ADDENDUM ORDER

ORDER NO. 1
DATE: 8/17/26
BID DATE: 8/26/26

NAME OF PROJECT: Desert Road Pump Station

OWNER: Clifton Water District

Sheet C2

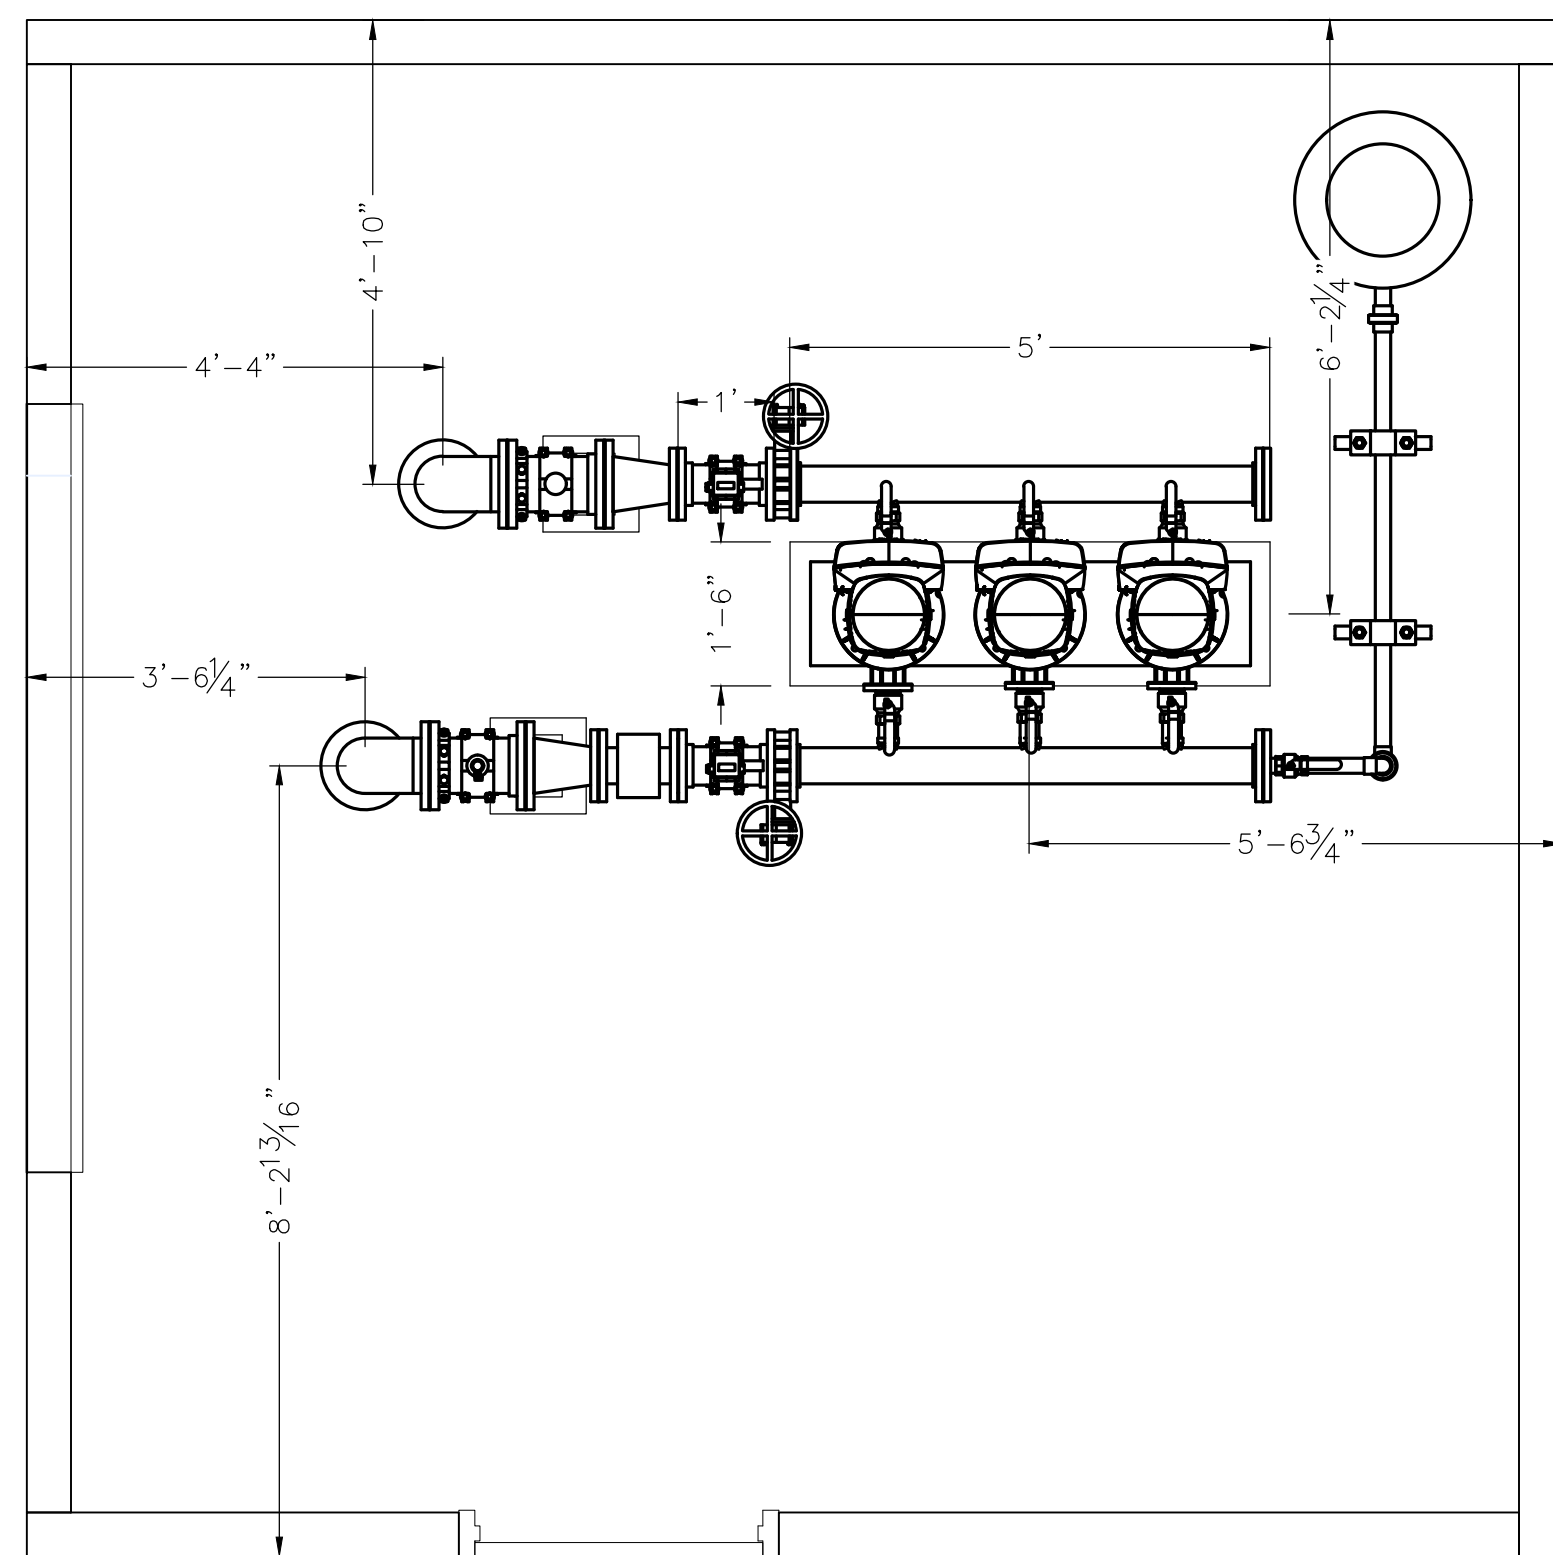
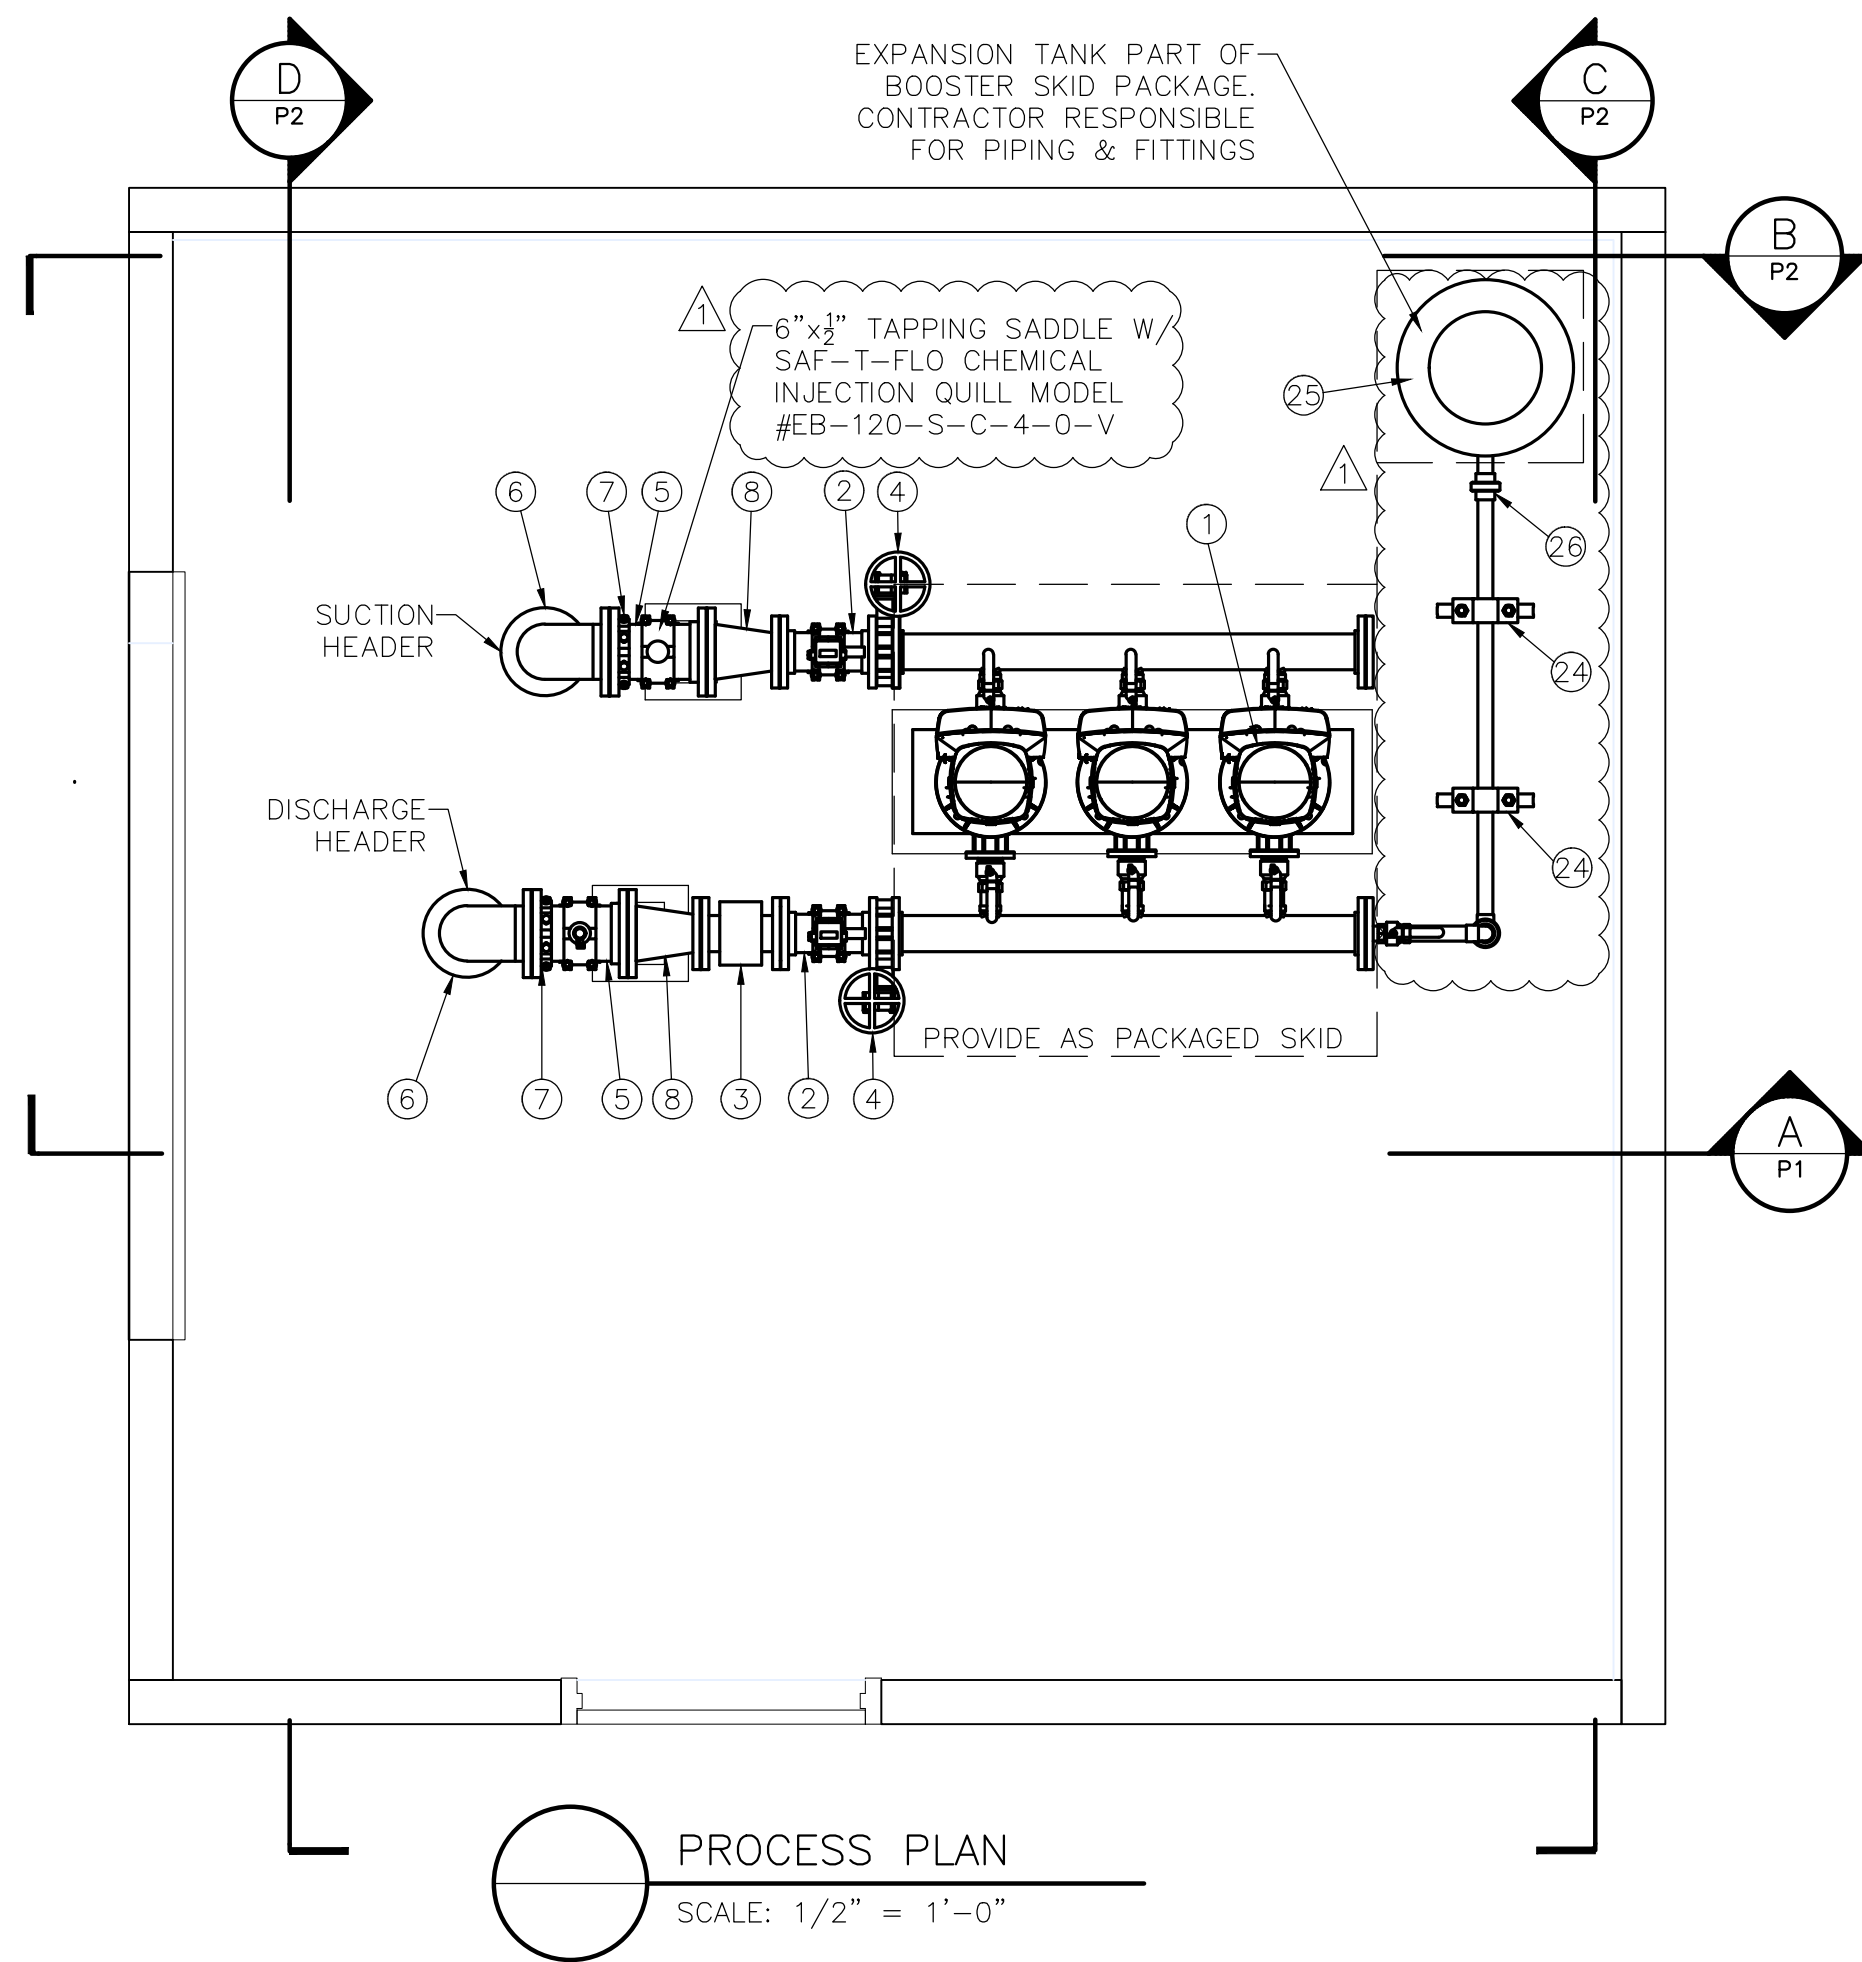
1. **Sheet C2**
 - a. Change suction side hot tap to cut in tee with valve
 - b. Added valve at suction side cut in location
2. **Sheet P1**
 - a. Added tap saddle and ball on suction piping
 - b. Added tap saddle and chemical injection quill on discharge piping
 - c. Added connection for expansion tank. (Expansion tank part of pump skid package. Piping and valves connecting pump skid and expansion tank is contractor responsibility)
